TSG-RAN Meeting #11   *RP-010086*
Palm Springs, CA, USA, 13 - 16 March 2001

Title: **Agreed CRs (Release '99) to TS 25.102**

Source: **TSG-RAN WG4**

Figure 6.1-a. Conditions for out-of-synch handling in the UE. The indicated thresholds Q_{out} and Q_{in} are only informative – continuous transmission.

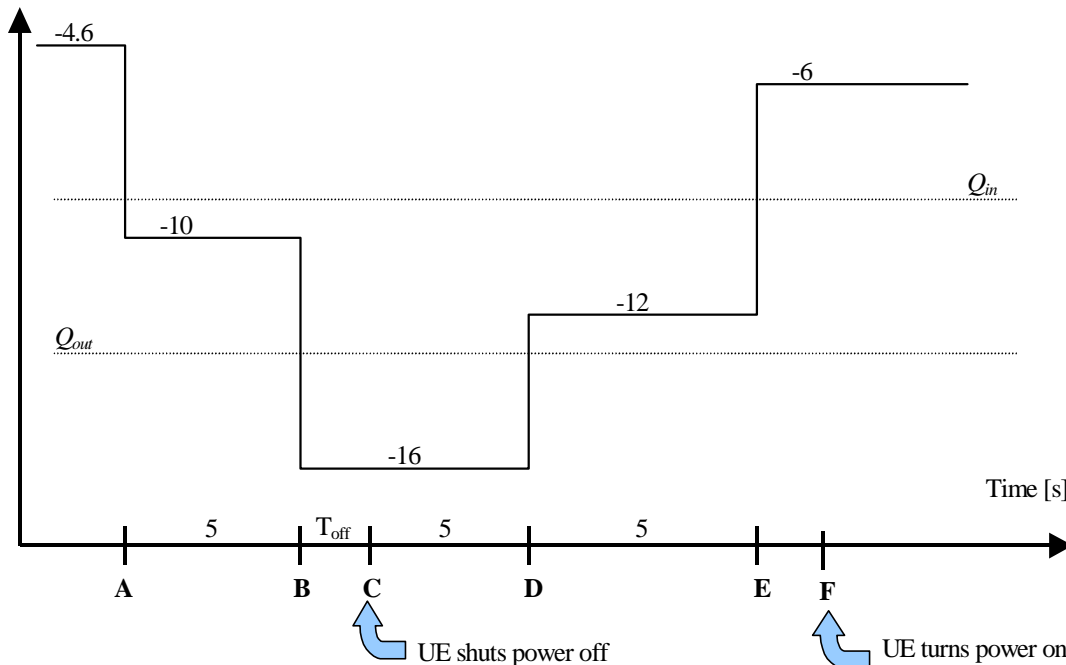
Reason for change:	⌘	WG1 Specification, TS25.224, has specified procedures for use of Special Bursts during DTX and has clarified the processing of these bursts to support Out-of-Sync Handling of output power. In prior version the test conditions used when testing the UE transmit power requirements did not include DTX.
Summary of change:	⌘	Include DTX in the test conditions used when testing UE transmit power requirements.
Consequences if not approved:	⌘	Test conditions are incomplete.

The conditions for when the UE shall shut its transmitter ~~on~~ off and when it shall turn it ~~off~~ on are defined by the parameters in Table 6.4-a together with the DPCH power level as defined in Figure 6.1-a.

The requirements for the UE are that
1. The UE shall not shut its transmitter off before point B.

2. The UE shall shut its transmitter off before point C, which is $T_{off} = 200$ ms after point B
3. The UE shall not turn its transmitter on between points C and E.
4. The UE shall turn its transmitter on before point F, which is $T_{on} = 200$ ms after Point E.

Figure 6.1-b. Conditions for out-of-synch handling in the UE - discontinuous transmission. The indicated thresholds Q_{sbout} and Q_{sbin} are only informative.

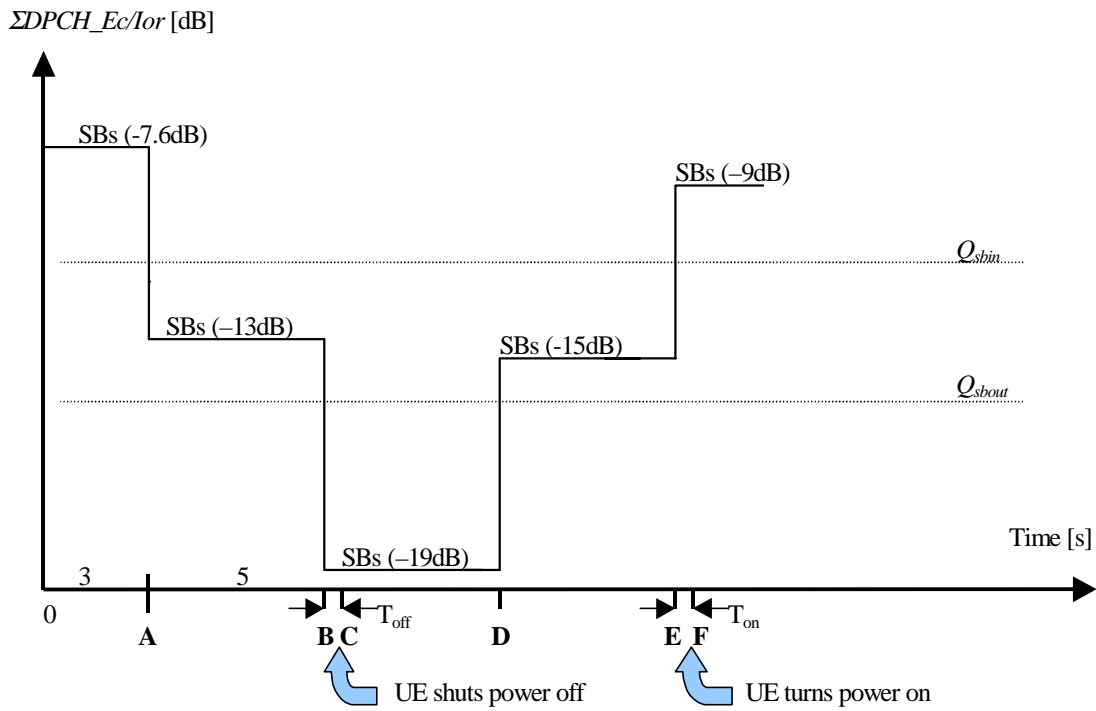
This test shall be done during a period of no data transmission. During this period, the conditions for when the UE shall shut its transmitter on or off are defined by the power level of the received Special Bursts, as defined in Figure 6.1-b.

The DCH parameters are shown in Table 6.4-b. While the normal data is transmitted using two channelization codes, the Special Burst is transmitted with only one channelization code. Therefore the total energy per chip during Special Bursts is 3 dB lower than for continuous data transmission. The Special Bursts are represented by "SBs" in the figure.

During the period of 3 frames with no data, the UE will receive a very low power, which is not shown in the figure. The power shown in the figure is the power of the Special Burst (which is 3dB lower than power for normal data, which is shown in Figure 6.1-a).

The requirements for the UE are that:

1. The UE shall not shut its transmitter off before point B.
2. The UE shall shut its transmitter off before point C, which is T_{off} = 200 ms after point B.
3. The UE shall not turn its transmitter on between points C and E.
4. The UE shall turn its transmitter on before point F, which is T_{on} = 200 ms after Point E.
